**Figure 83-6—Example 10:4 PMA bit mux**

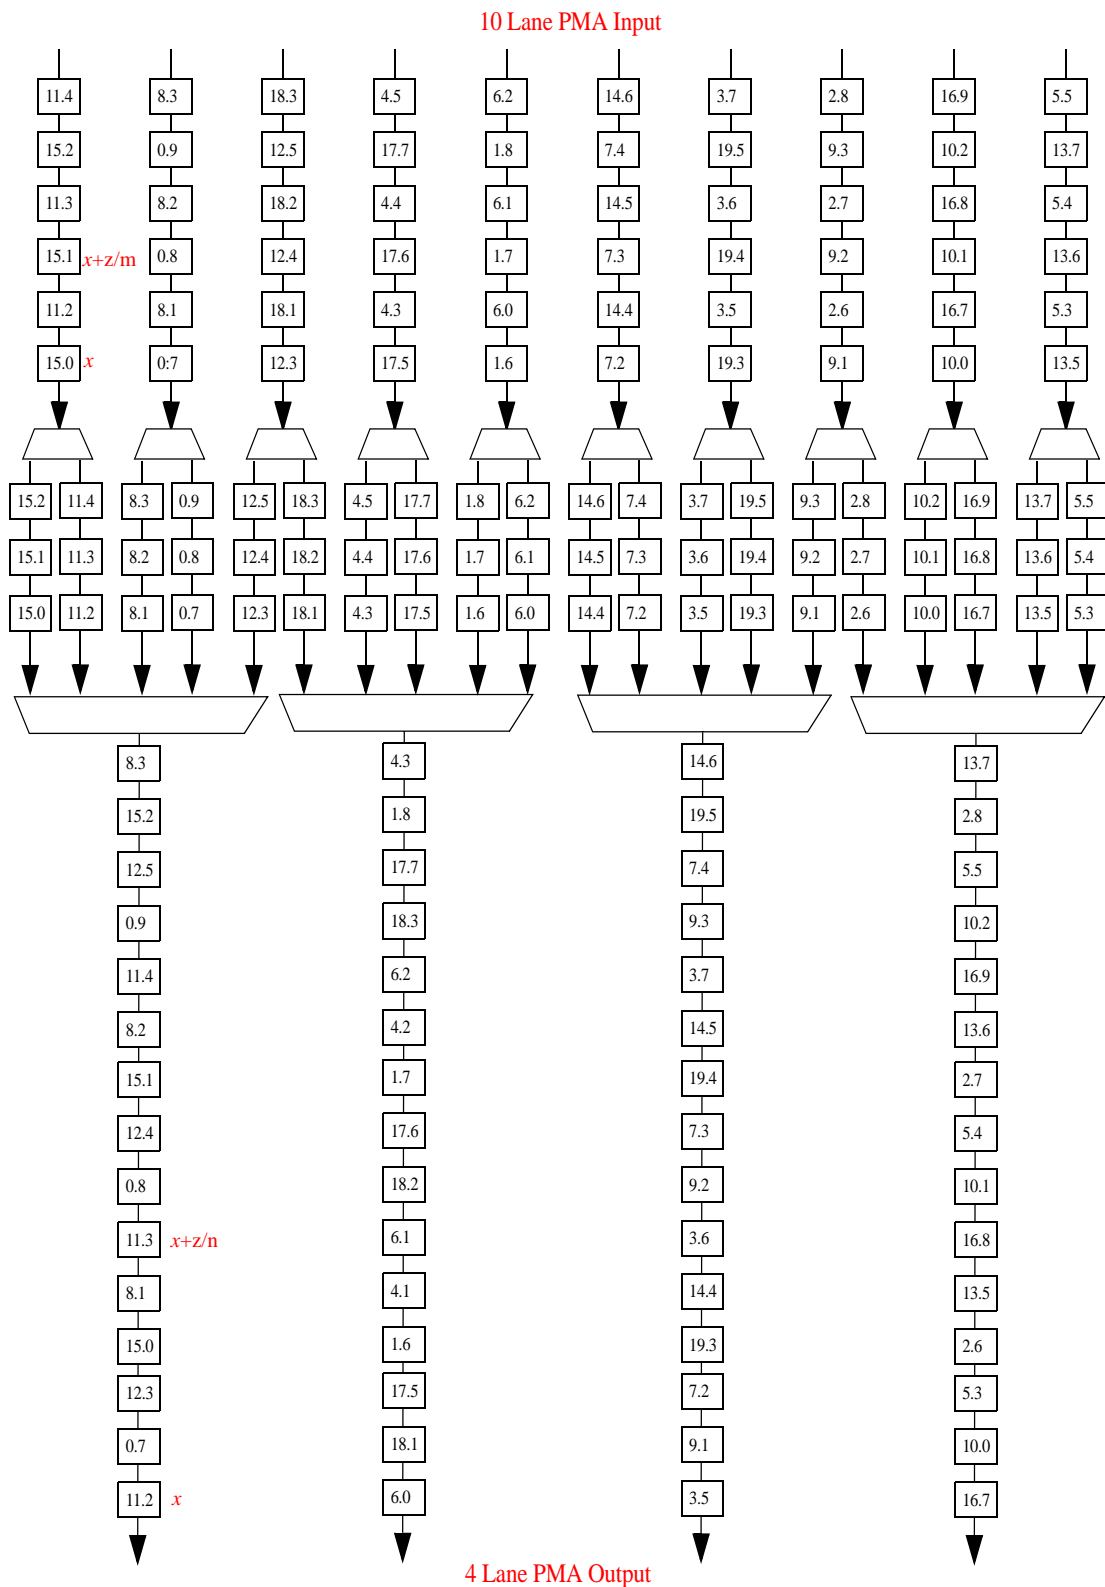
Each PCSL received in any temporal position on an input lane is transferred into a temporal position on an output lane. As the PCS (see Clause 82) has fully flexible receive logic, an implementation is free to perform the mapping of PCSLs from input lanes to output lanes without constraint. ~~From the time the link is brought up, the mapping of each PCSL from an input lane to a particular output lane shall be maintained.~~ Figure 83–6 illustrates one possible bit ordering for a 10:4 PMA bit mux. Other bit orderings are also valid.

NOTE: i.k indicates bit **ik** on PCSL **ki**. Skew may exist between PCSLs.
